ADDENDUM NO. 3

SUBJECT: Addendum No. 3 – Magnolia Avenue Streetscape Project

PROJECT NO.: 15A-R-0584 & 16A-R-0609

REV. R.M.U.	(SUBMITTED)	<i>Floyd G. Hardy</i>	NUMBER 1033F
REDR. G.M.E.		STATE ROAD & AIRPORT DESIGN ENGR.	
CHK. R.K.C.	(APPROVED)	<i>Thomas D. Mordue</i>	
		STATE HIGHWAY ENGINEER

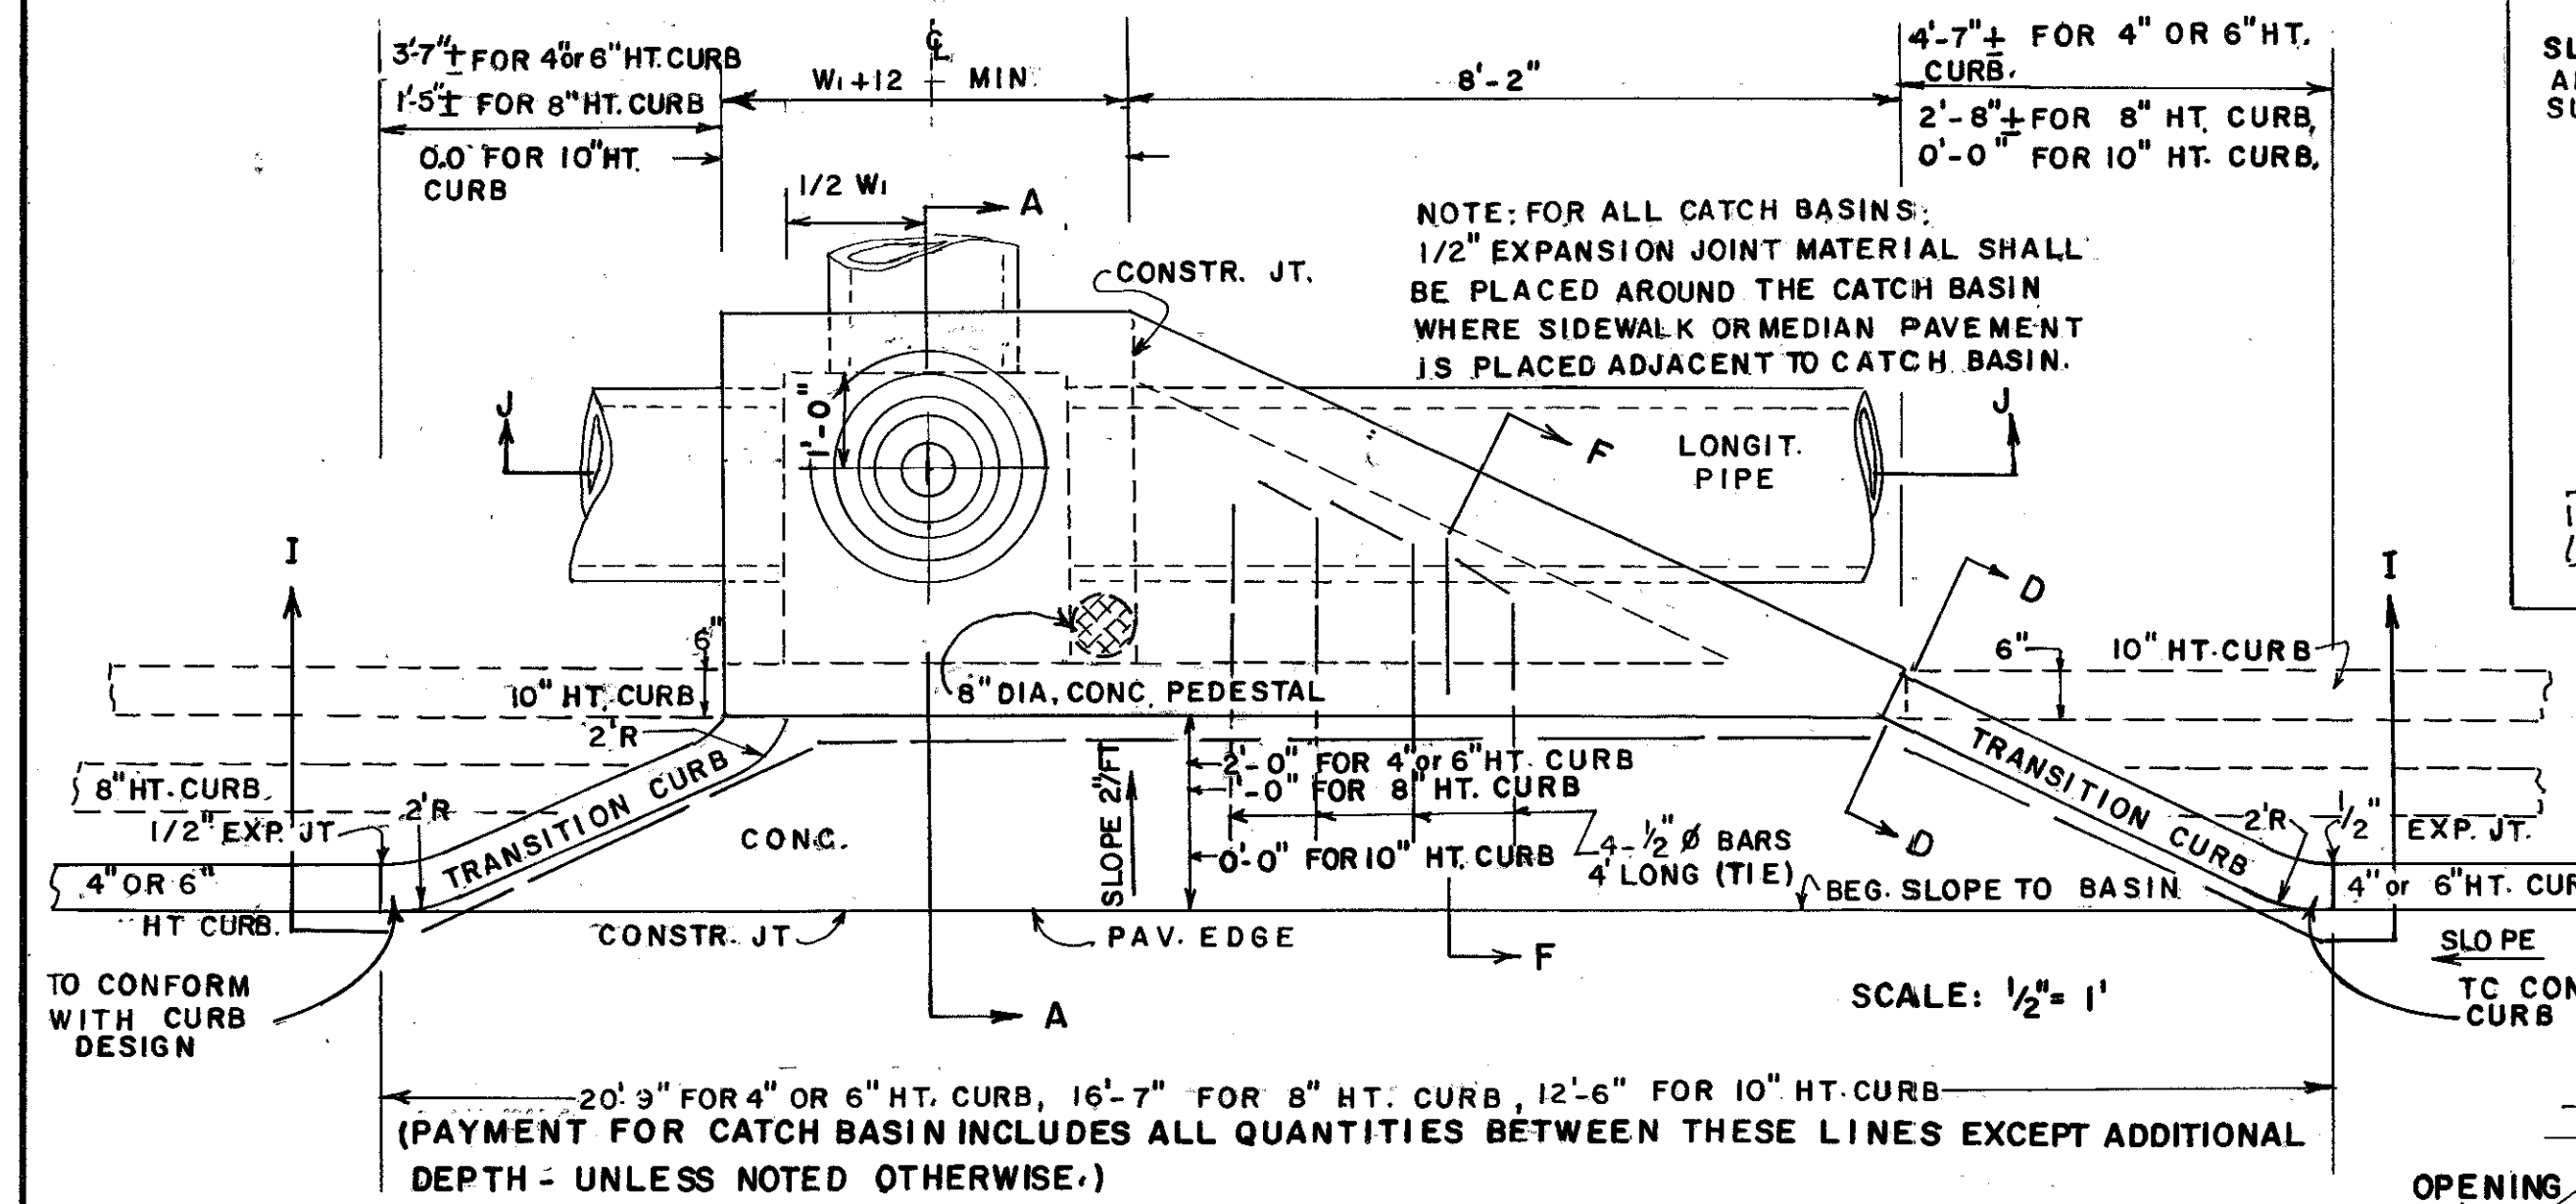
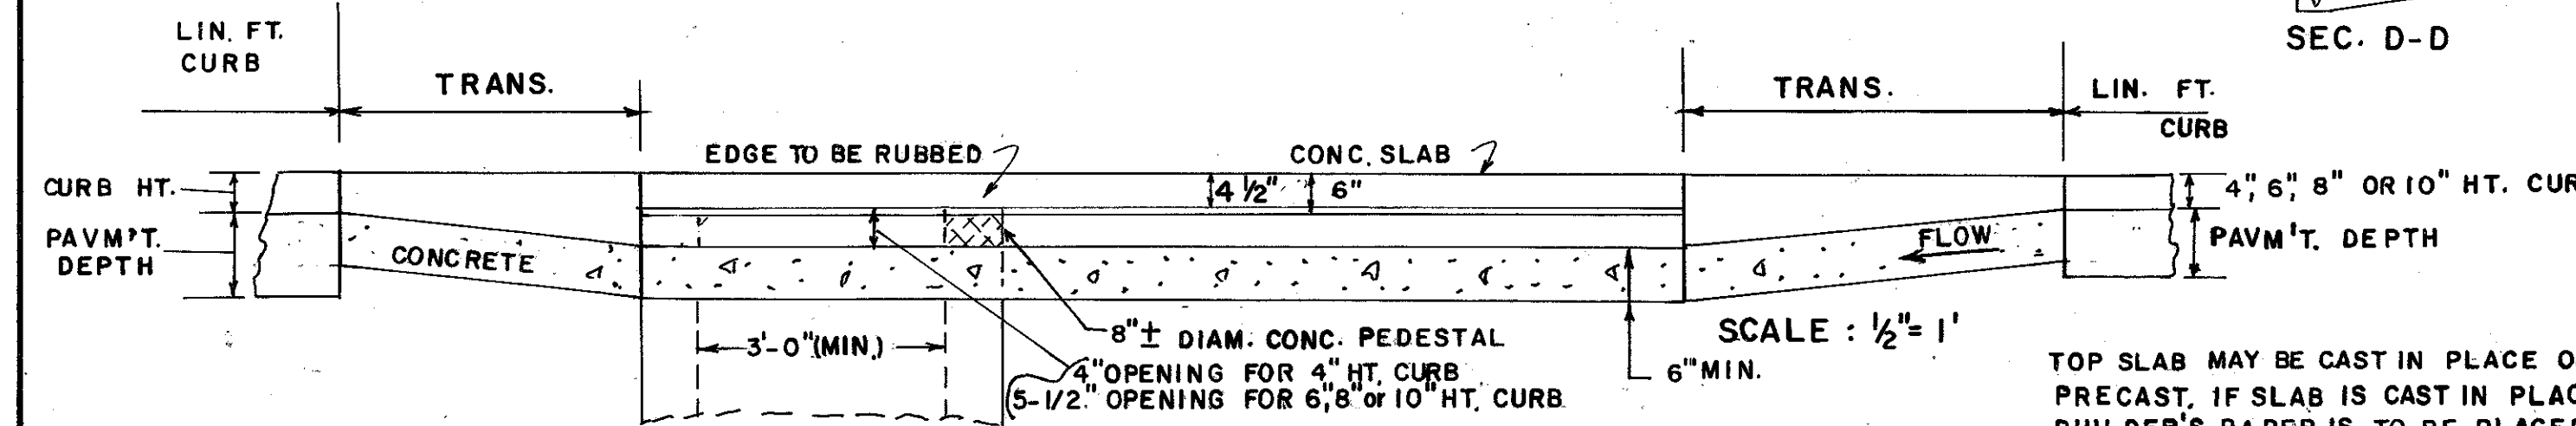
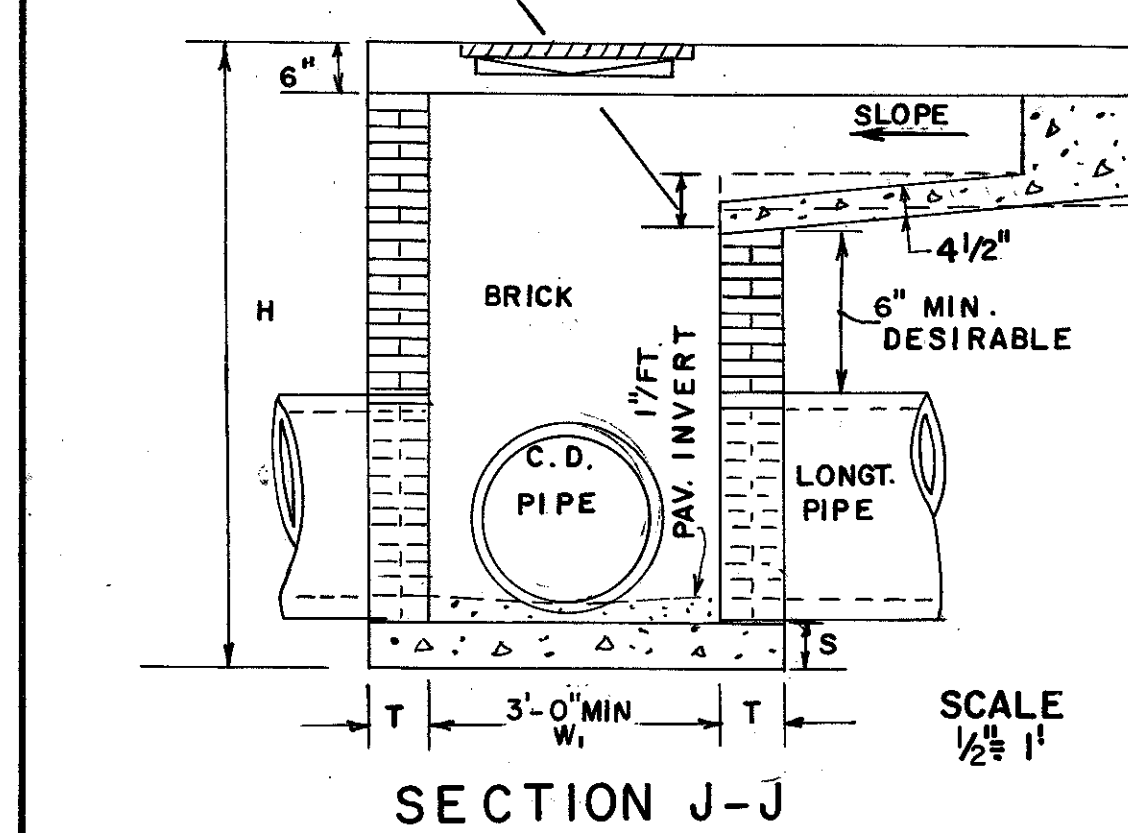
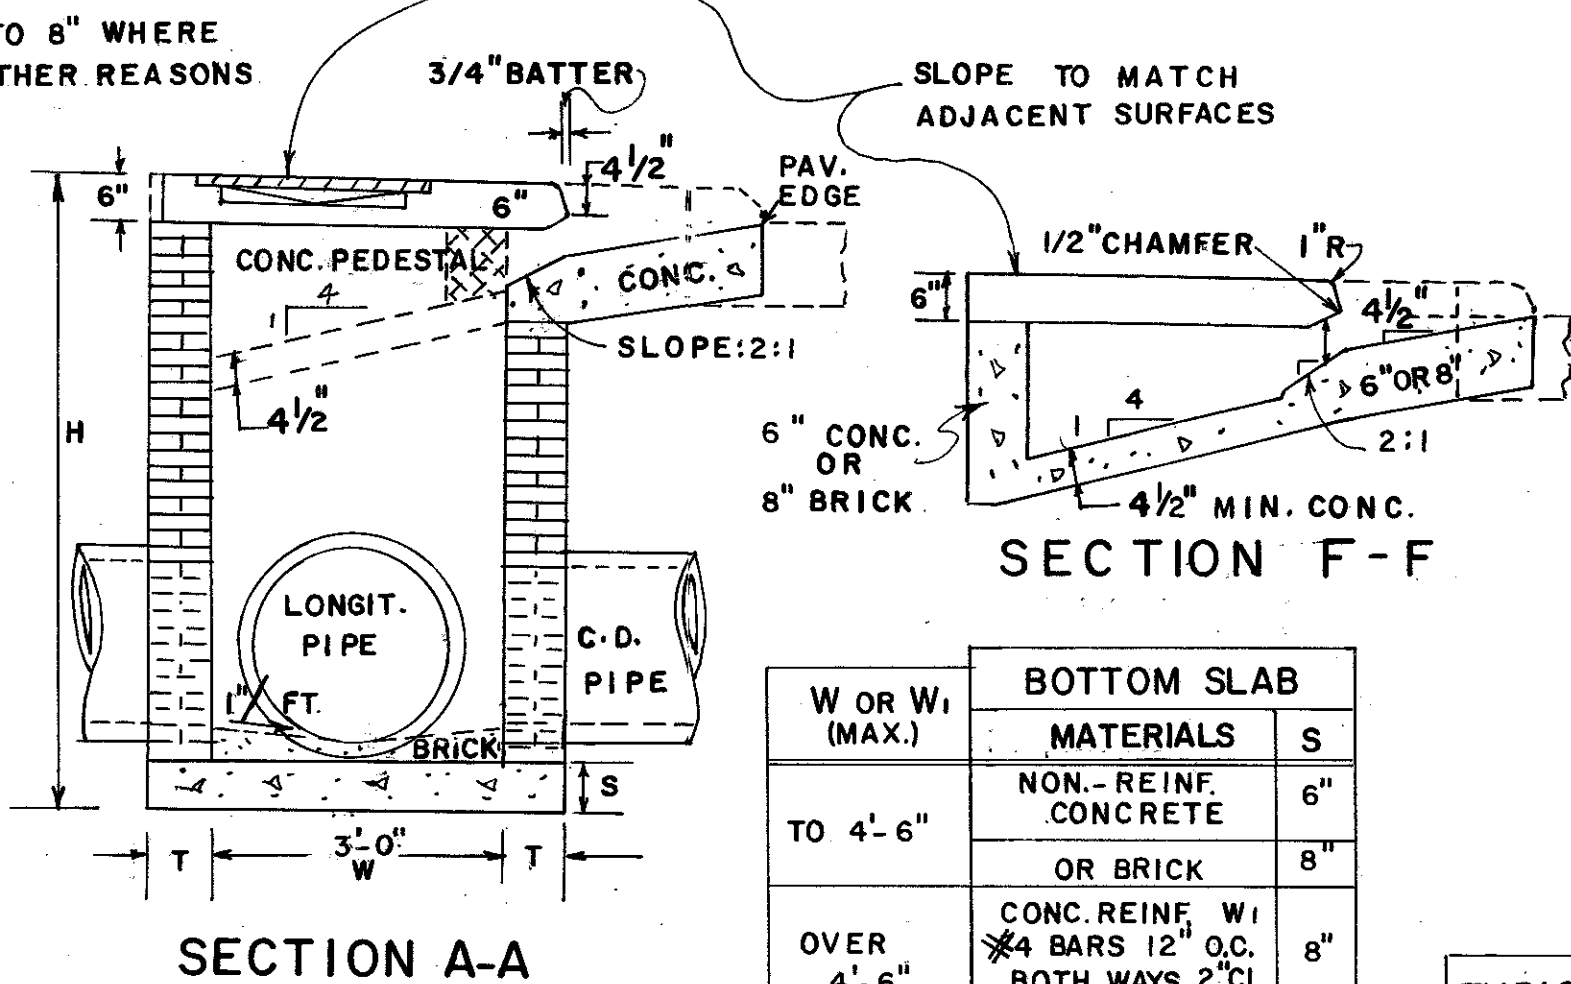
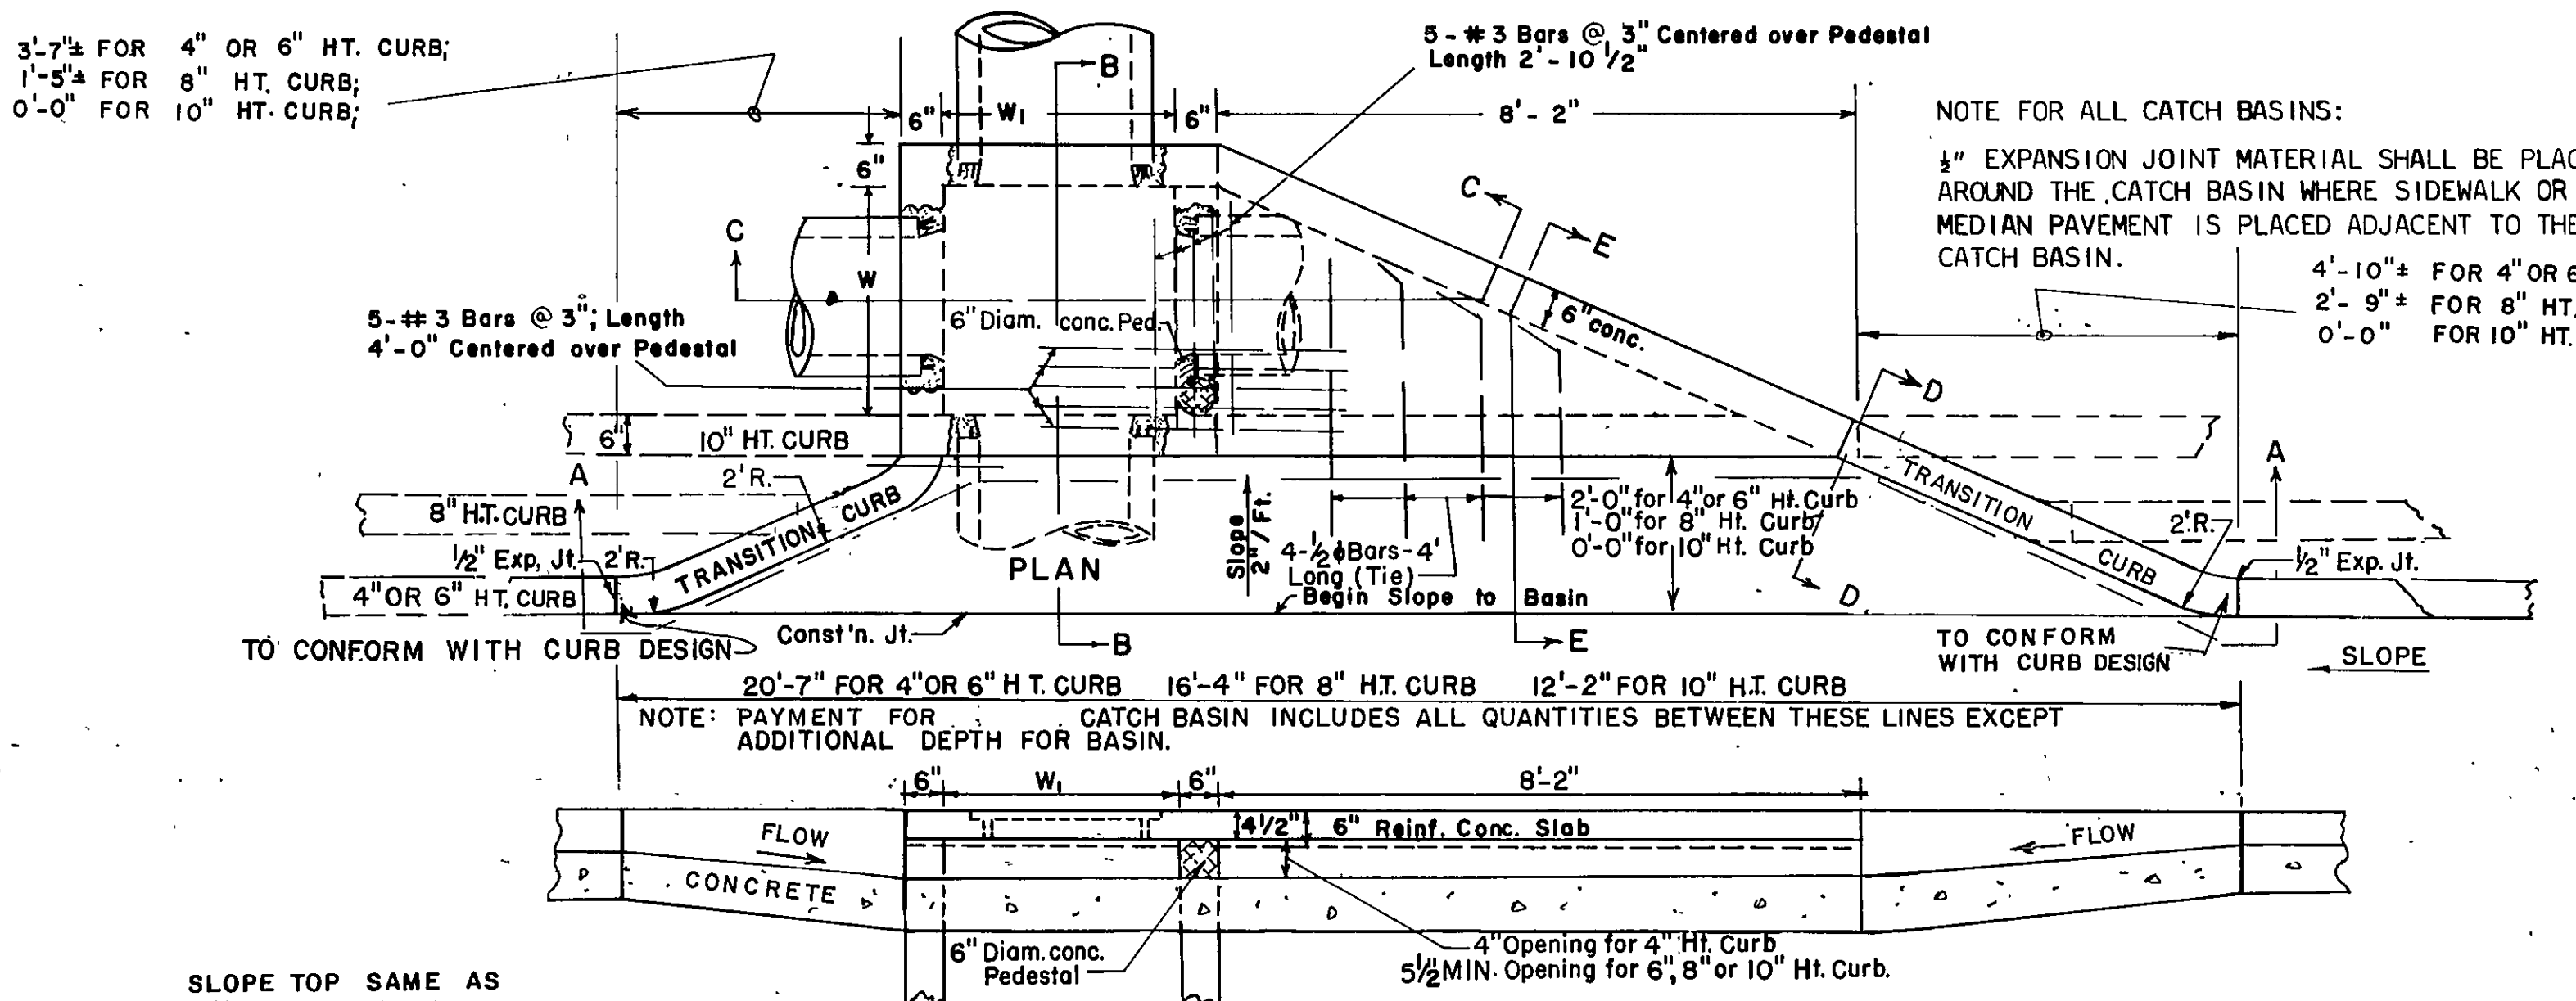
Question #18: Can precast be used for the GDOT Throated Inlets?

Question #28: Please provide specifications and details for Bid Item 22.12.6 GDOT Throated Inlet 1033F.

Response: Yes, GDOT has standard details for both precast and cast in place versions of the 1033F type basin. Details of the precast and cast in place version of the GDOT 1033F basin are included in this addendum.

Response: Details of precast and cast in place version of the GDOT 1033F basin are included in this addendum.
